Revision	Description	Date
A	Initial Release	?
B	As built changes: E990211-00-C	5/99
C	1. Added compensation networks to coil drivers with capacitors, Cadd1 through Cadd10 and resistors Radd1 through Radd5 2. Changed coil driver 183 ohm (R202, R216, R229, R243, R256) to 125 ohm, 2 Watt for ITMX and ITMY and to 183 ohm 1 watt on all other chassis. 3. Cadd1 through Cadd14 added to board to stabilize and limit high freq gain of 1Hz zero, 40Hz pole compensation stage. 4. Dadd1 through Dadd20 added to coil driver for op amp input protection.	2/00
D	Added Radd6, Radd7, Radd8, Radd9 to terminate unused inputs of MAX333 switches per E010178-00.	10/01
D1	Removed two stages of chebychev filter for each degree of freedom per E010181-00.	10/01
D2	Added note (sheet 1) about replacement of input matrix MAX509s with fixed resistors per E010184-00.	10/01

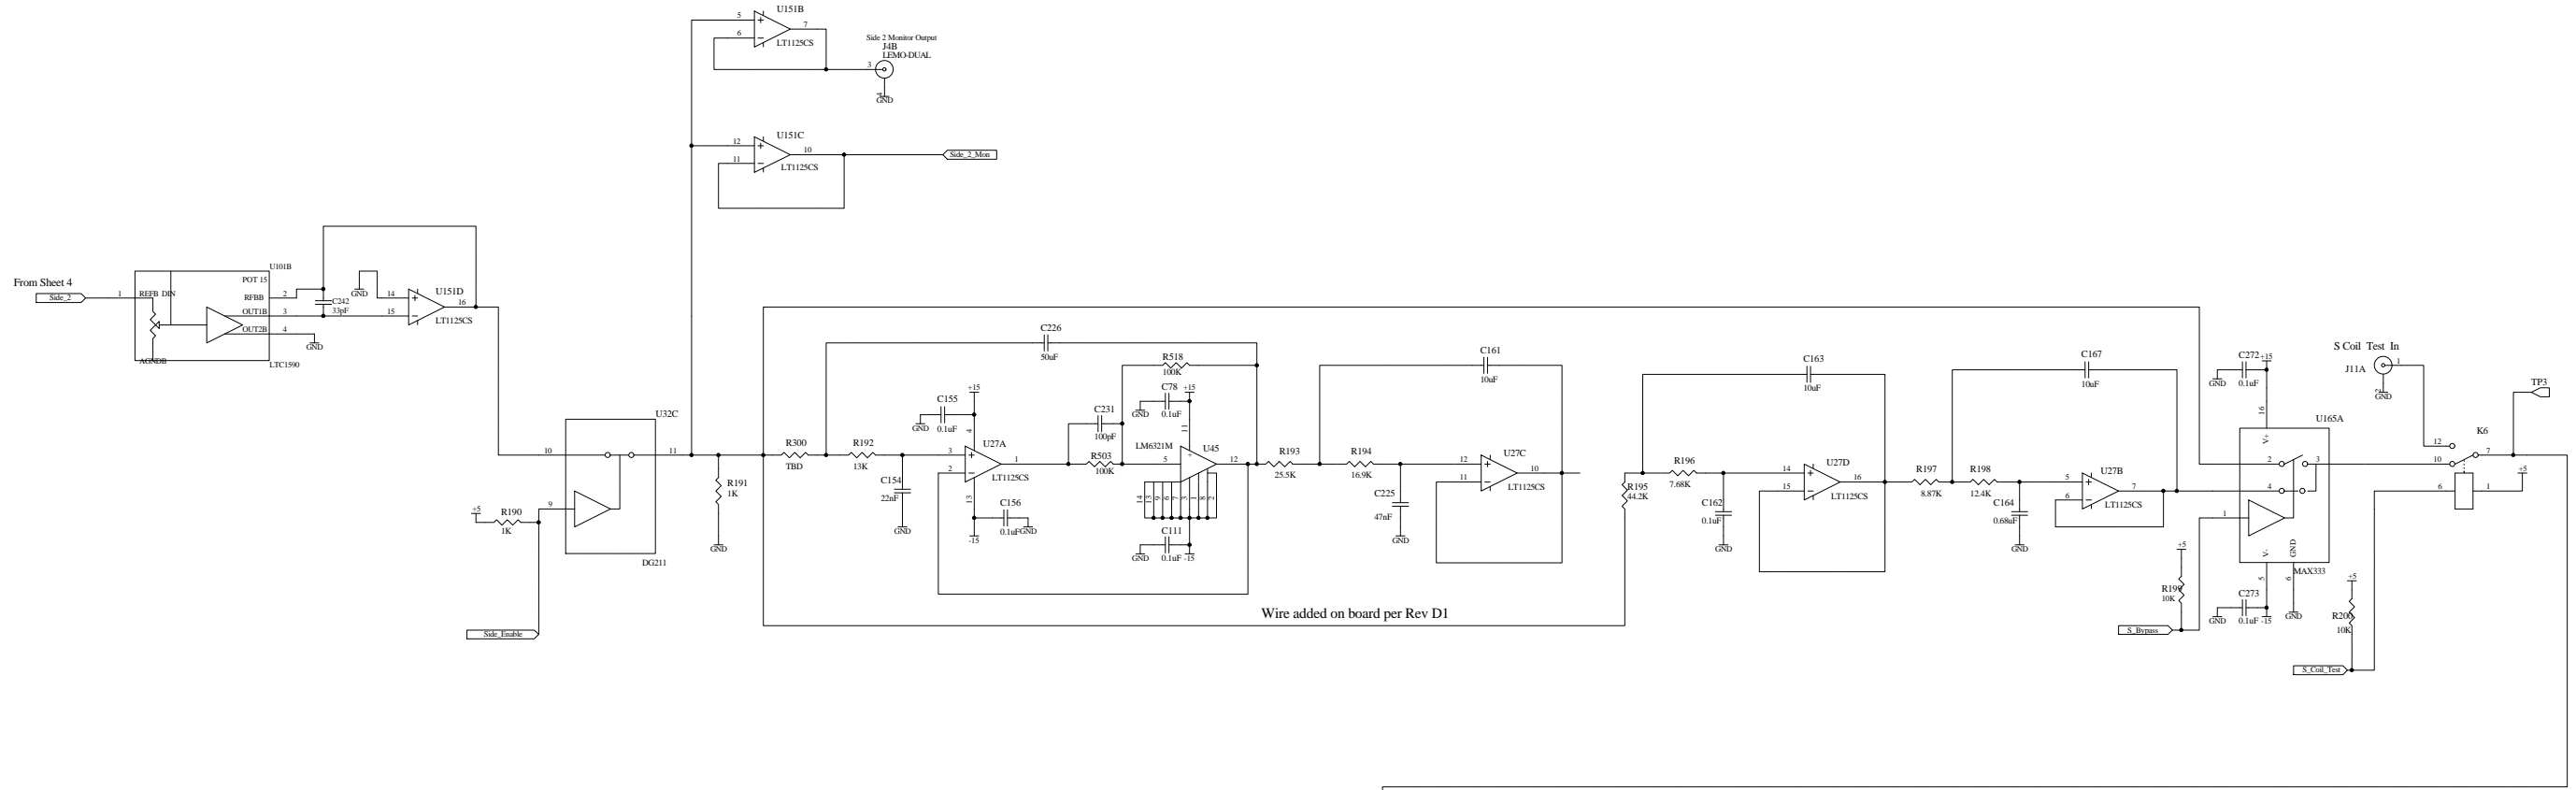
Note:
402 ohm resistor and 10uF capacitor are not stuffed on LOS controllers for the RCM and BS or any optic that is always run in the acquire mode.

Note:
402 ohm resistor and 10uF capacitor are not stuffed on LOS controllers for the RCM and BS or any optic that is always run in the acquire mode.

Note: PA85 feedback Cap and resistor added on bottom of board

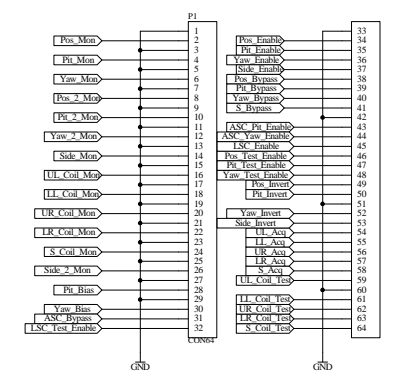
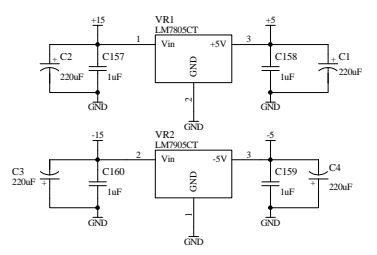
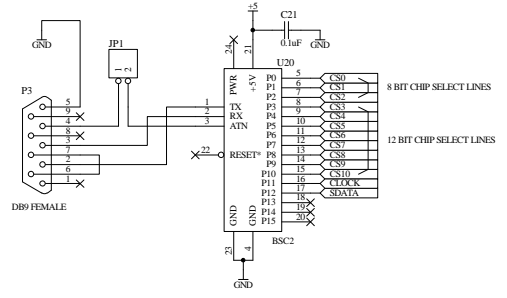
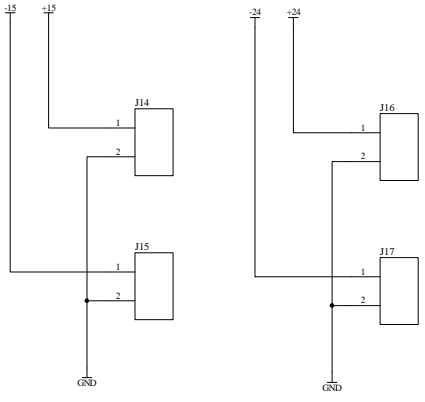
Note:
The wiring to the daughter card was changed after board manufacture. The actual connections to the board are made via wires to the coil driver outputs. The PD connections remain as shown.
An interface board (ref. D990022) is used for this function.
